# Response to Review #1

The authors developed an operational algorithm to retrieve the aerosol effective height (AEH) using the slant column density of the oxygen dimer (O2-O2) at 477 nm from the Geostationary Environment Monitoring Spectrometer (GEMS). This algorithm was applied in GEMS observation domain from January to June 2021 and provided important aerosol vertical height information for severe dust plumes over East Asia and anthropogenic aerosol pollutants over India. GEMS AEH product was also compared with CALIOP and TROPOMI aerosol layer height in this study. Although this product provides important data source for diurnal variation of aerosol vertical distribution information and deserves to be published, there are many unclear descriptions in the manuscript and the presentation quality, especially the English writing style needs to be improved. The detailed comments are as follows:

# Response to Review #2

Figure 5. Intercomparison of (a) AEH between CALIOP and GEMS and (b) ALH from TROPOMI and AEH from GEMS (black dot and error bar is mean and standard deviation in 20% interval of each TROPOMI ALH) over the period from March 28 to 30, 2021.

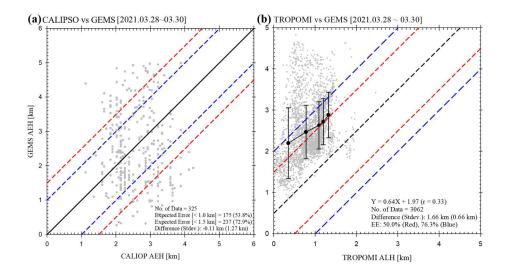
13. Figure 4: When comparing GEMS AEH with CALIOP, I notice that for the same CALIOP AEH, the GEMS AEH shows large variation. For example, for those pixels with 2 km AEH from CALIOP, the GEMS AEH changes from 0.2 km to 5 km. What is the reason for this phenomenon? Maybe adding figures showing CALIOP aerosol extinction profiles helps. How is the correlation between CALIOP and GEMS AEH? What do the black dots and error bars in panel (b) represent?

Ans) Thank you for your comment. We checked the statistical results in these cases and found that some collocated pixels are overlapped. Although these overlapped pixels can be averaged during the statistical process, the comparison result are estimating from different pixels. Except to the effect of overlapped comparison results, the retrieval around the 2 km AEH from CALIOP is not from single plume regions. In addition, the captions of Figures 5 and 8 were revised to explain the black dots and error bars in panel (b).

Figure 8. Intercomparison of (a) AEH between CALIOP and GEMS, and (b) ALH from TROPOMI and AEH from GEMS (black dot and error bar is mean and standard deviation in 20% interval of each TROPOMI ALH) on April 26, 2021.

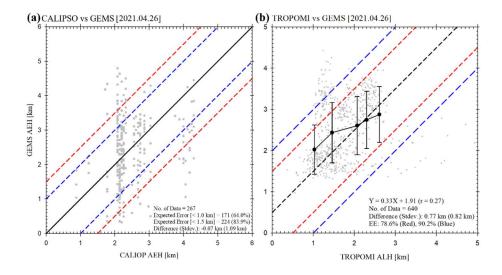
11. Figure 2: Add the CALIOP tracks used in later analysis in the map here, and also in Figure 5.

*Ans) We modified the figures for adding the CALIOP tracks in Figures 4 and 7 in the revised manuscript.*
